Ranson Road Residential Subdivision Sketch Plan

PART 1: PROJECT SUMMARY

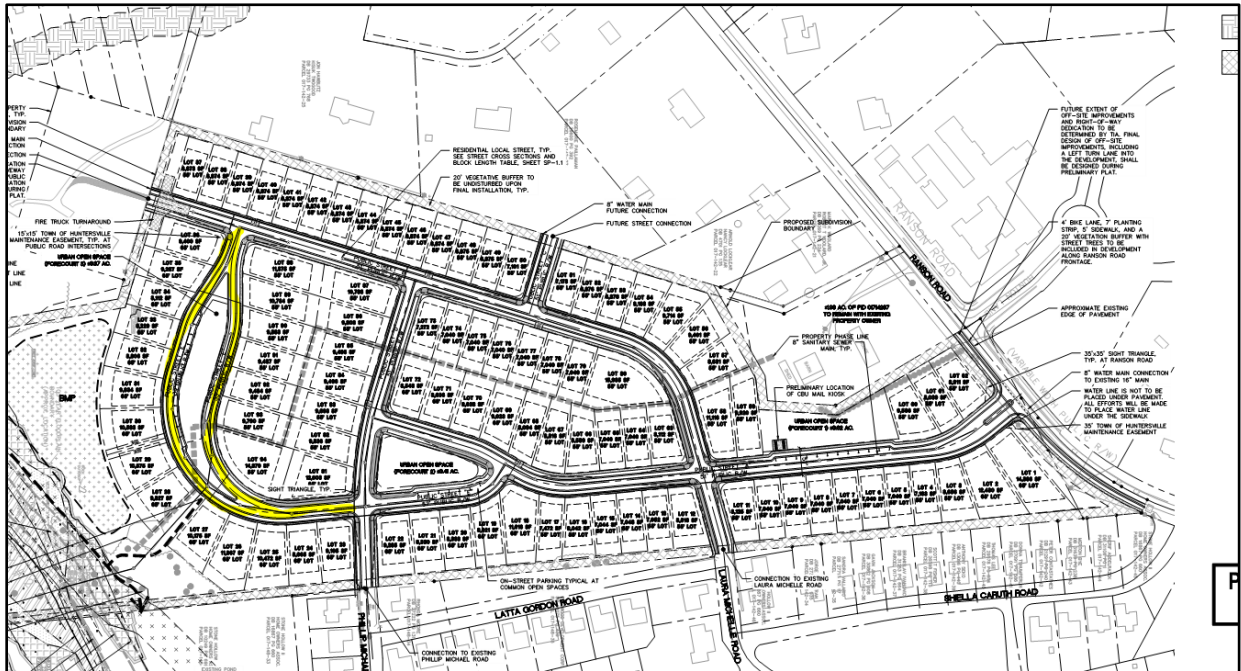
5. Street standards, connectivity and setbacks are all compliant with the zoning and subdivision ordinance, except the two streets outlined in yellow. The applicant is requesting a block length waiver. Eastbound is a total of 949.41 linear feet and westbound is a total of 829.61 linear feet. Within Article 5 states, "Where longer blocks will result in an arrangement of street connections, lots and public space more consistent with this Article and Article 7 of these regulations, the Town Board may authorize greater block lengths at the time of subdivision sketch plan review and approval". Planning Staff is in favor of the block length waiver request. The lengthening of the block creates an opportunity for a larger forecourt – urban open space.
